TAG. Ball sometimes falls into bottom of cabinet instead of lodging in Tracy Island lift mechanism.

www.homepin.com/kits/subway_adjustment.pdf November 2018 © Homepin Ltd (HK) --000000--

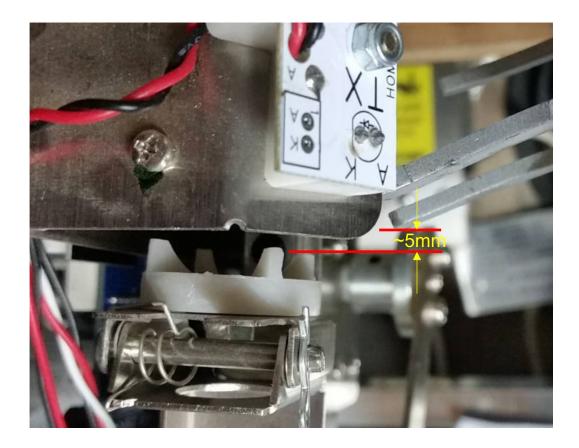
Cause: Usually this is a result of the subway wireframe not being adjusted correctly.

Remedy: Some early production machines will require the ends of the wireframe to be bent – please follow the description below.

Lift the playfield and remove the subway wireform (3 screws).

Confirm the bend on the ends of the frame as well as the adjustment height of the mounting bracket conforms to the following pictures.

Once the subway wireform is confirmed to fit the measurements, re-fit it to the playfield so the end of the wireform meets the Tracy Island mechanism with the measurements shown below.

The mounting position of the wireform at the ball entry end is not critical.
